COUNTY OF SAN MATEO - PLANNING AND BUILDING DEPARTMENT

# ATTACHMENT X

Re: Re-Circulated Initial Study and Mitigated Negative Declaration: Zmay 3-Lot Minor Subdivision, Grading Permit and Resource Management (RM) Permits, County File Number: PLN 2014-00410, Project Location: 1551 Crystal Springs Road, San Mateo unincorporated Baywood Park Area, APN: 038-131-110.

Figure 1. Wetlands identified from ref [4A, pg. 115]

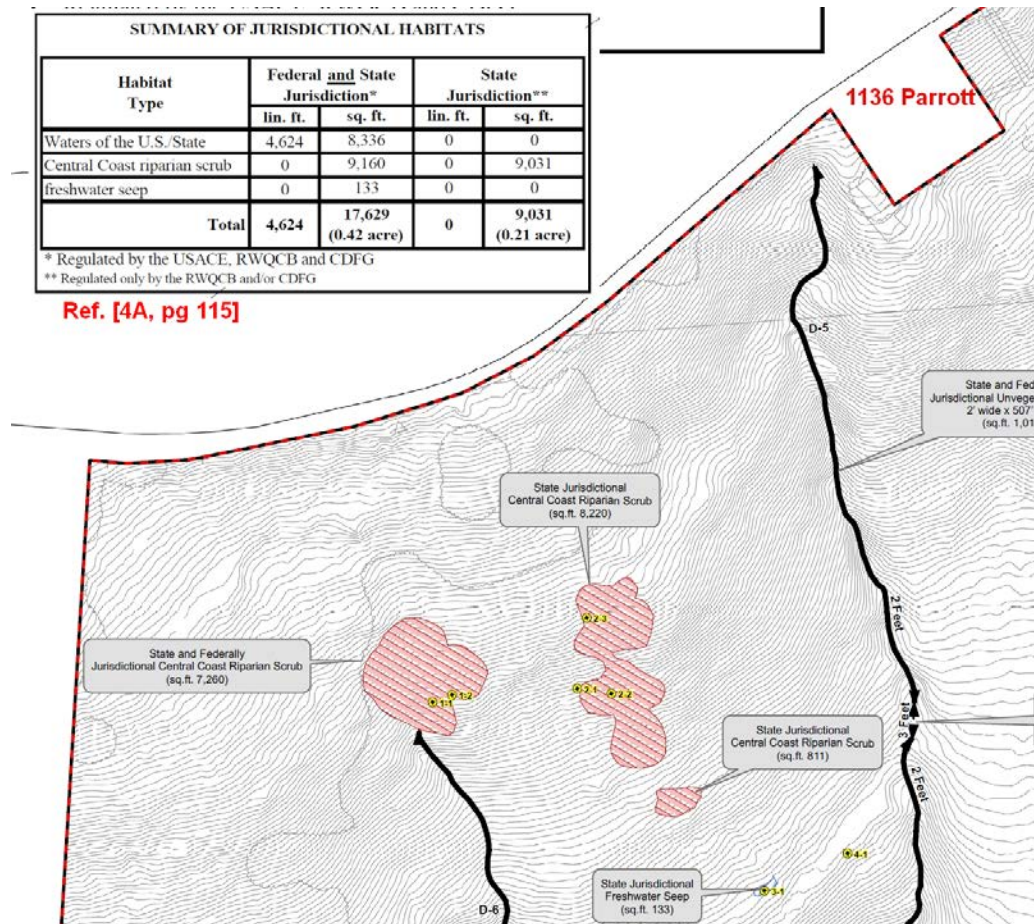
Consider the question, where does the source water come from to support the Federal and State regulated waters identified in the biological [4A, pg.105] report revised in 2015 and again in 2017[3A, pg.97]? The identified wetlands are shown in Figure 1 below.

According to the biologist report from Wood Biological Consulting, Inc the groundwater source is “... nuisance water (ie, run off from irrigation or leaking storm/sewer lines)” [4A, pg.17]. In the geotechnical reports by Murry Engineering Inc., there was ground water observed in various bore holes B-4, B-5 and B-6 that are located within the house parcels. Even though the bore holes were done in the middle of summertime CA when everything is dry the source of the was never explained. However, they did note there could be fluctuations in the level of groundwater due to variations in rainfall, temperature, and landscaping [5A, pg.18]. Yet somehow, the wetlands have survived, on a steep hillside, facing the western sun, over the course of multiple years, from the first survey and all of the updates including recent California drought times. This is a lack of attention to the environment, an omission by San Mateo County and is contrary to the Planning Department mission statement.

Figure 2. Subdivision plots from the Tobin Clark estate and Parrott Drive subdivisions built in the early 1950's with storm water flow pathways. Orange was the initial flow path. Blue arrows are current flow.

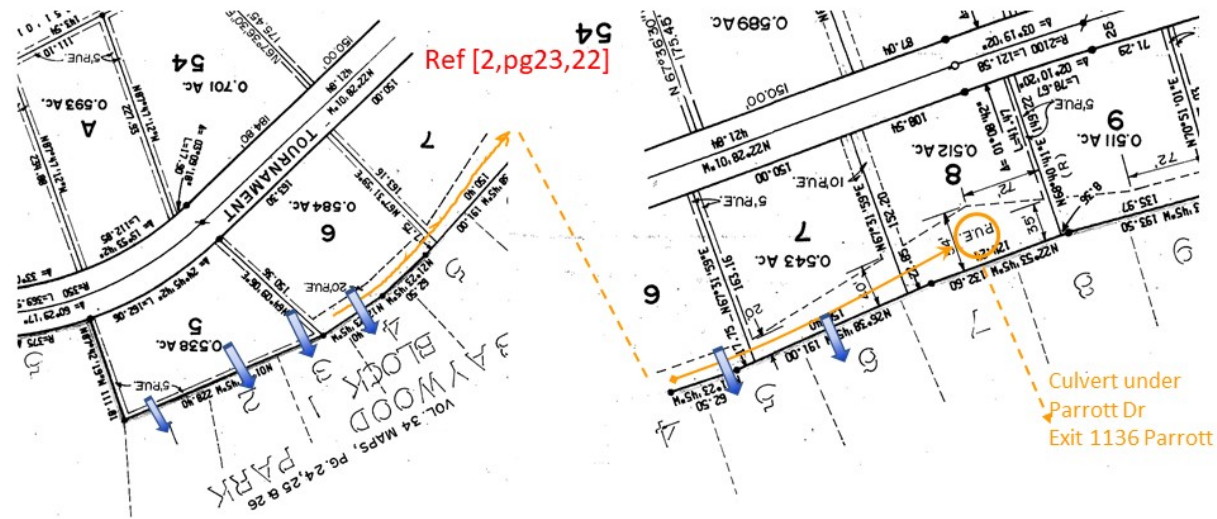
Figure 2 below, from reference [2], shows the sub-division plots from the Tobin Clark Estate and Parrot Drive houses built in the early 1950’s. These are the top of hill properties that are located above the two swales that span the two wetlands in the Zmay parcels. Note in particular there is a Public Utilities Easement (P.U.E) along the back of the Tournament Drive houses. Visiting the area on foot one observes

that the P.U.E is an open surface drain trench along the hill top leading to a culvert drain with top grate behind lot seven on Parrott Drive. At that point the culvert goes underground to exit on the north side of 1136 Parrott Drive.

Over the ensuing ~70 years the open drainage trench has been filled with natural debris and flow along the P.U.E. restricted from back yard fences that have been installed. Consequently, the current storm water flow, from the very hilltop, is now over the hillside into the steeply sloped backyards of the residences along Parrott Drive as shown with the blue arrows in figure 2. In discussion with local neighbors, five out of six of the lots along Parrott Drive bordering the Zmay sub-division development have experienced surface debris landslides. The new retaining walls can be seen from Parrott Drive roadway.

*Figure 4. Photograph standing on the west side of Parrott Dr looking down towards the wetlands. One can observe several Elderberry bushes in the direction towards the wetlands. (just out of view)*

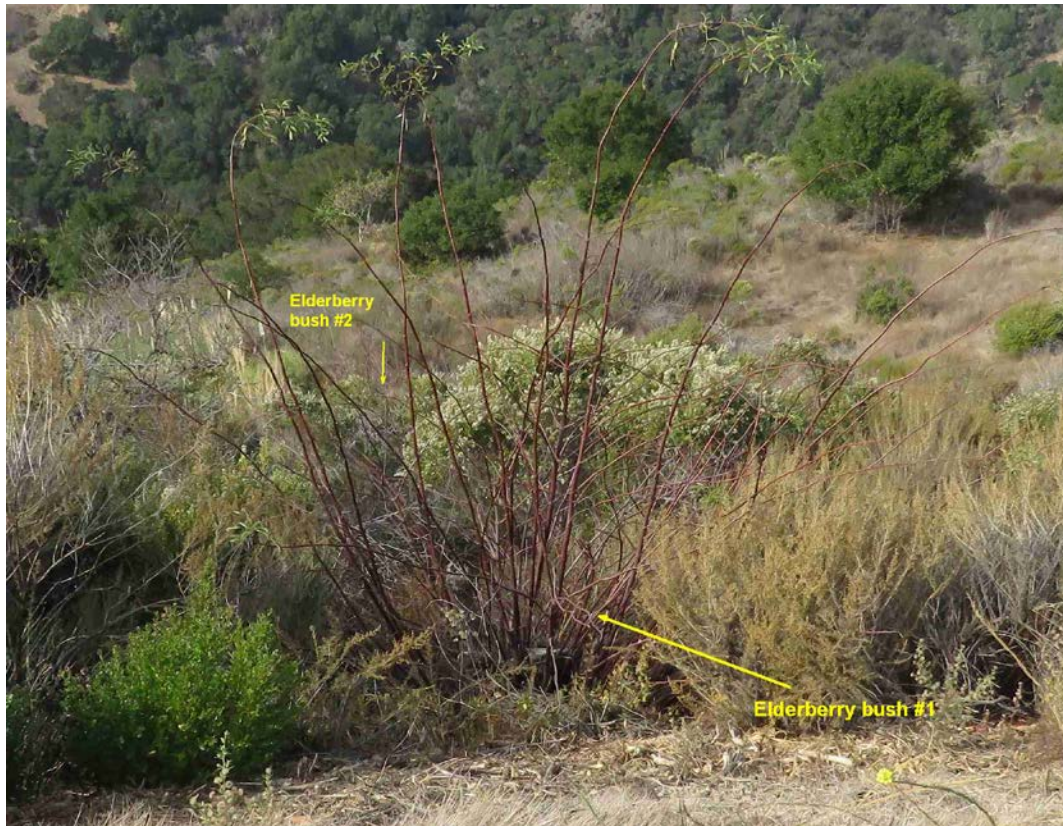
Finally, by walking along the west side of Parrott Drive, opposite to the house at 1111 Parrott drive, one can observe a few Elderberry bushes. They extend down the hill in a line towards the wetland areas. See Figure 4. Elderberry bushes require a large amount of water to grow successfully. Also, their roots are rather shallow. So, the only source of water for these plants is the underground moisture flow from the east, uphill side, of Parrott Drive. The various Parrot Drive dry wells are clearly uphill from the riparian habits. Thus, as the sub-surface water travels down the sun parched, west hillside from Parrott Drive it must be relatively near the surface as evidenced by the Elderberry bushes

Figure 5. Bore Holes near parcels 1 through 4. No house pad on 2<sup>nd</sup> from left in updates

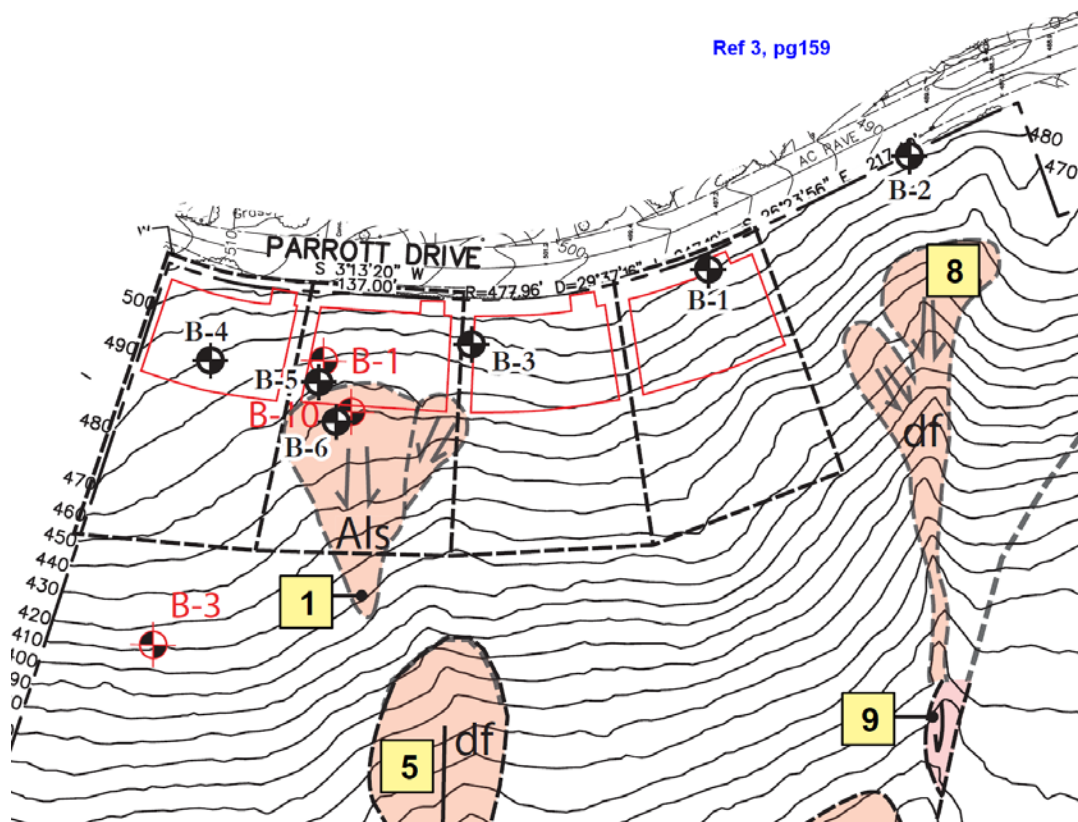
With respect to the geotechnical data, within the proposed final three lot boundaries, there are only a very few bore holes. As mentioned above, there was ground water observed in a few bore holes, B-4, B-5 and B-6 [5A, pg.18]. These are located within the new parcels in Figure 5 below [3, pg.159]. However, there is very little hydrological information presented. Furthermore, the specific rock structure of the bore holes has been omitted from all reports from these important parcels. So, the specific layers transporting the water cannot be determined. Only generalizations based on widely dispersed bore holes which are not very helpful. However, bore hole #B-4 explicitly is mentioned to have hit “bedrock” at 18” [5A, pg.15 bottom]. Because of the shallow bedrock depth, it can be concluded any and all nearby grading activities can potentially disrupt the below ground water flow. All of which depends greatly on the subsurface topology and of porosity for the various Franciscan soil complexes that make up the general site area. It is interesting to note, the source of the water in the bore holes was never explained, even considering the bore holes were done in the middle of summertime of normal CA dryness

So clearly there is self-staining, and active sub-surface hydrology, on the Zmay parcels underdevelopment which have not been analyzed. Furthermore, the source of the water for the wetlands encompasses a large collection area from uphill surface topology, which are explicitly being injected into the below ground topology. Given the bench like, stepped topography, of Parrott Drive road bed, the Parrott Drive east side house pads, and the top of the hill Tournament properties there could be local underground pools providing year over year, source water for the wetlands. It then

Figure 6a Pier stitched drainage areas, and 6b and house pad 10' walls typical

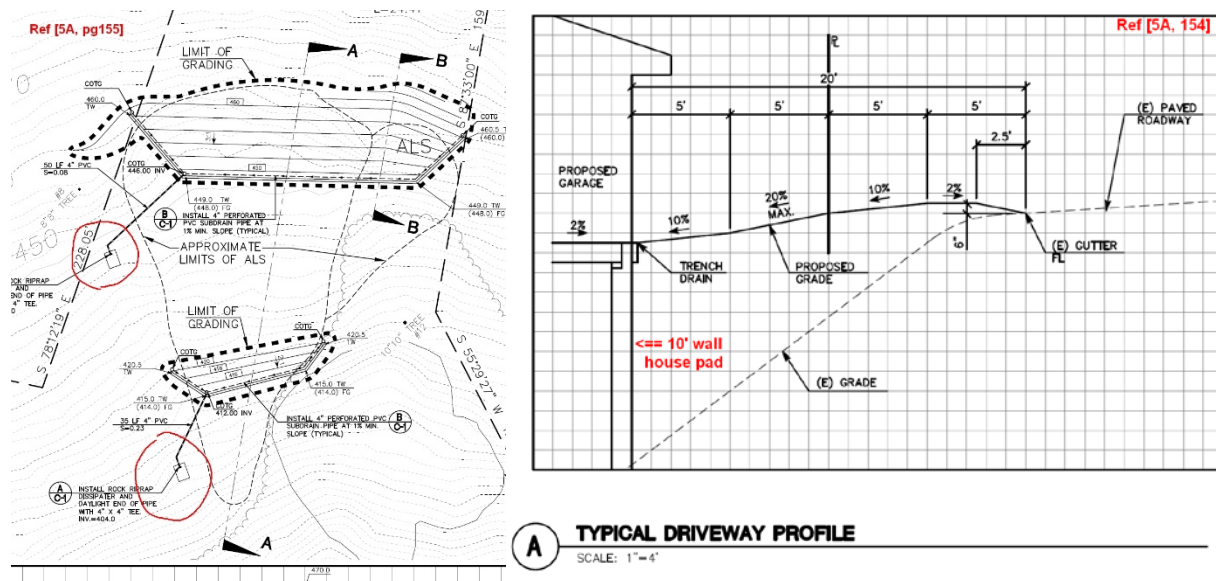
Also notice in Figure 6a, the outlets for stitched pier subdrains, circled in red, are clearly directed off northward into open spaces. No longer on a downward gradient to the wetlands. Thus, diverting vital ground water flowing down the central fall line away from the wetlands.

Figure 7. Drainage piping (in red) for each lot installed during the initial grading process.

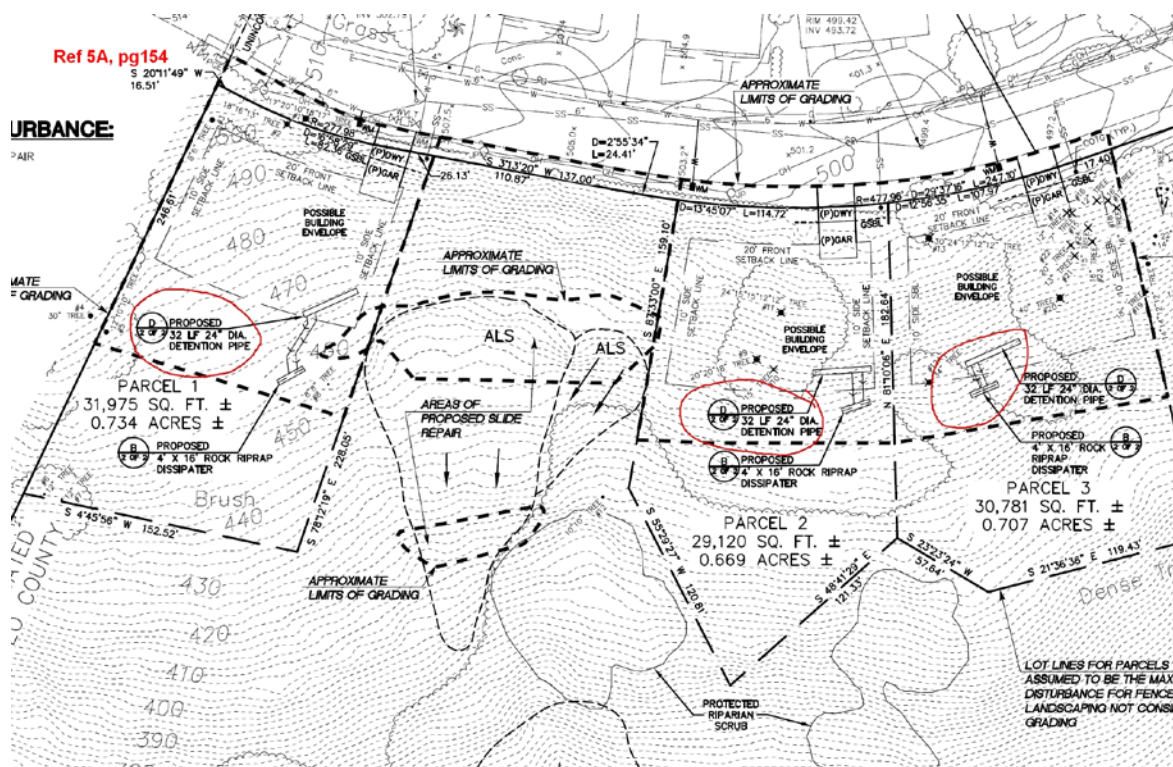
Finally, the initial grading and ground preparation process will be installing water detention drainage piping on the three house pads, which will divert the water without consideration for the wetlands. See Figure 7 [5A, pg 154] where the detention drainage is shown in the red circles. Again, the impact to the sub-surface water flow feeding the riparian areas has not been evaluated. So, without careful consideration for the sub-surface, ground water flow pattern, the water source, and flow channels, essential for the survival of the wetlands and riparian areas could easily be blocked or diverted due to grading or detention pipe drainage. Thus, leading to the demise of the wetlands.

In summary, the natural flow of water from Parrott Drive at the top of the swale, containing each of the riparian areas and downward is the source of water for the wetlands. Blocking of this source water with retaining house walls, any change in water quality, or diversion from drainage piping for the house parcels, or the two stitched pier walls drain piping, or disturbance of the flow pattern from grading cuts, or tire tracks from equipment, has not been analyzed in terms of what changes may be brought on by the various direct or indirect effects of grading activities and arbitrarily installed storm drainage.

Figure 13 Areas of potential rainfall induced landslide

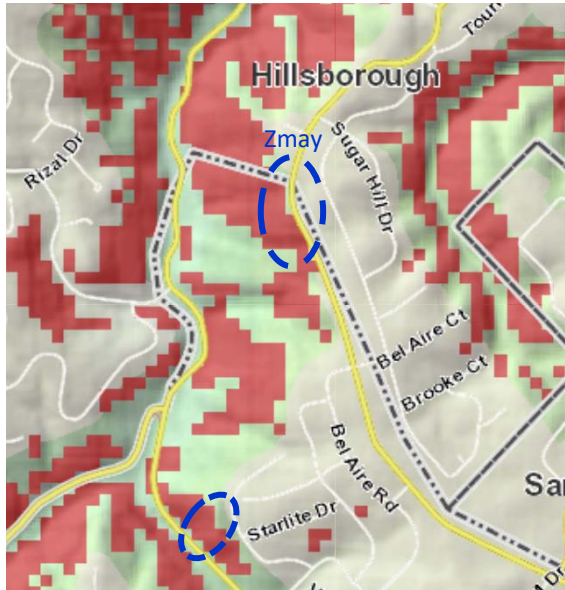
In addition, in Figure 13 in the blue dashed circles, it shows both the Polhemus slide and the Zmay parcels are susceptible to rainfall induced landslides.

Figure 14 Overlay showing size of potential landslides

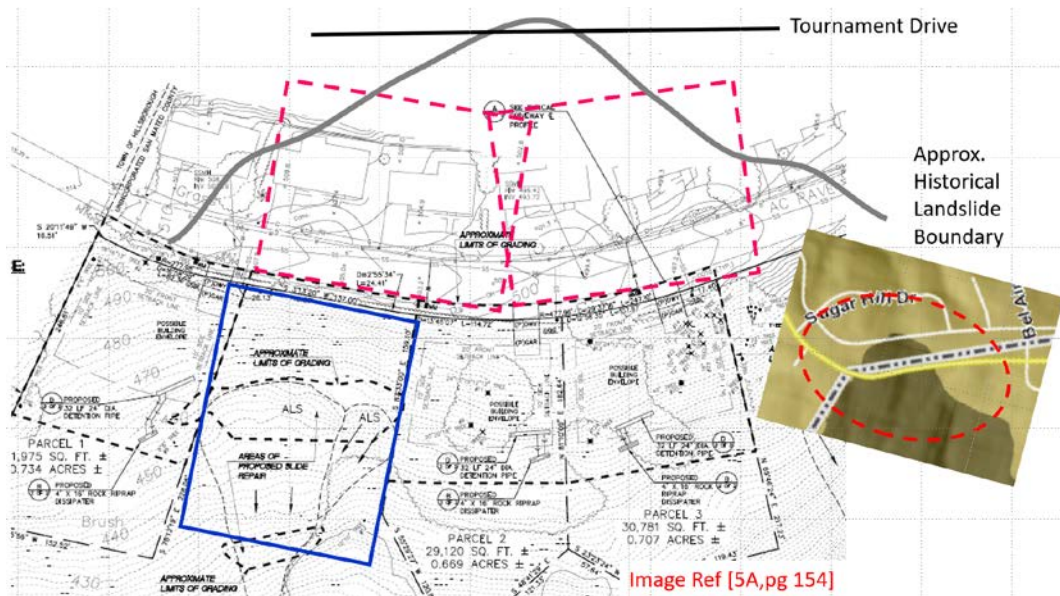
The amount of ground volume targeted to be held in place by the stitched pier walls on the Zmay property is shown by the blue rectangle. It is scaled to be 160 ft wide by 200 ft long with a depth of 10 feet (not shown)[8a pg.1]. However, the historical slide area shown in the ABAG image on the right-hand side extends across Parrott Drive and in one small area all the way up to Tournament Drive in Hillsborough. The red dashed rectangles are copied to be the same size as the blue rectangle.

As can be seen, they show the potential landslide volume could be 3 times larger (Blue + 2xRed) than the original design (Blue). Thus, the design safety factor of 1.3 [8b pg2] used for the Zmay stitched pier walls is not adequate due lack of analysis from external factors.

Figure 15 Sanitary Sewer Overflows since 1/1/2007

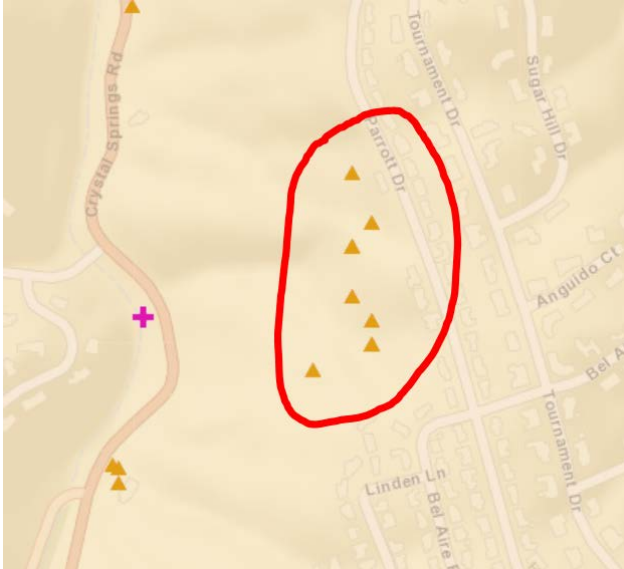
The sewer connection is something that is needed for the houses, not the grading. So, it will be deferred. However, the developer chose the site for the new development in part due to the availability of utility and sewer connections [5A, pg 133]. According to the Sanitary Sewer Overflow (SSO) Incident

Map shown in Figure 15, [5] the “Billy Goat Hill” gravity sewer pipe connection has had more than seven SSOs since 2007 due to storm water ground motion on the open space parcel. The MND has no information regarding the plan to meet the San Mateo County Dept. Public Works requirements for sewer attachment due to the increase volume requirement from the three new parcels.

Figure 1 - Locations where we measured the slopes - approximated.

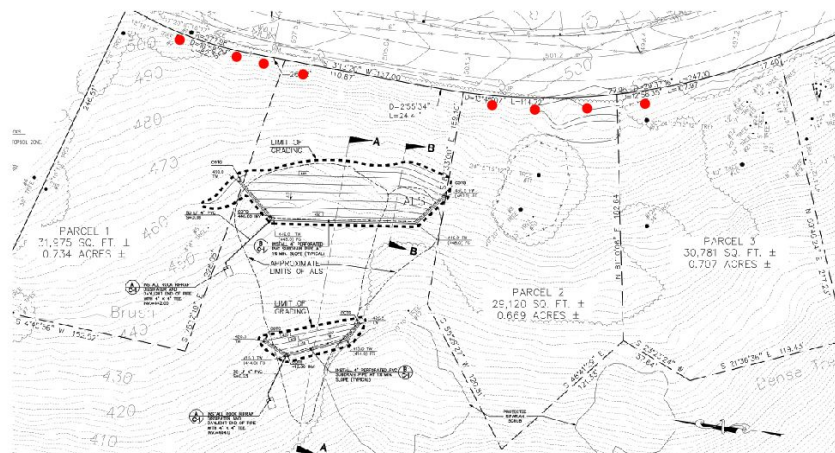
● we measured the slopes on these locations

Figure 3 -Landslides on and next to proposed site

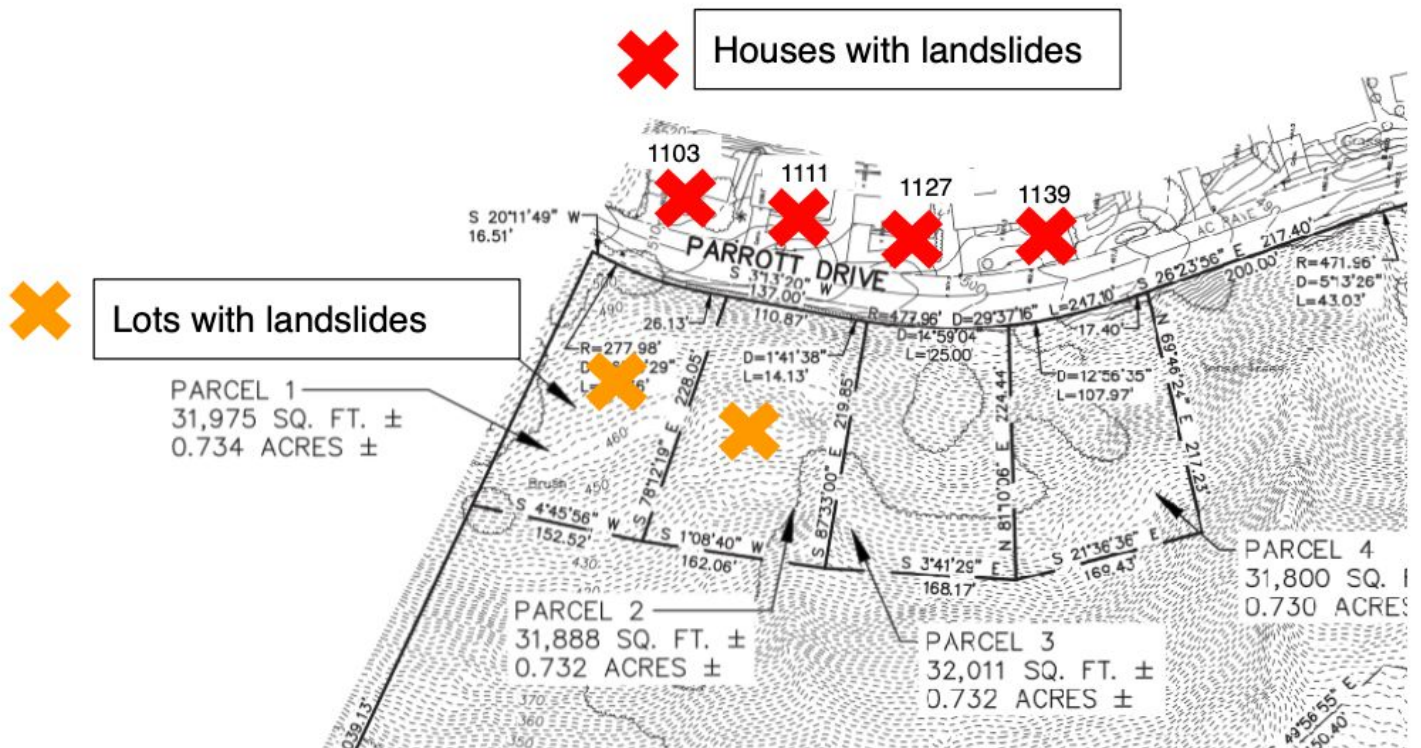
- ALL 4 houses across the road from the development had significant landslides.
- Lot 1 and lot 2 have landslides.
- There are at least 6 landslides in the immediate area.
- The potential for more landslides on all lots, especially with the grading, construction and addition of tons of earth for the filling, is severe...

- The landslide on lot 1, though mentioned on many pages of the MND (for example “*within the active landslide on lot 1*” Attachment K, Page 18 ), is not shown on the maps in the MND!
- See below a map from an older application of this project.
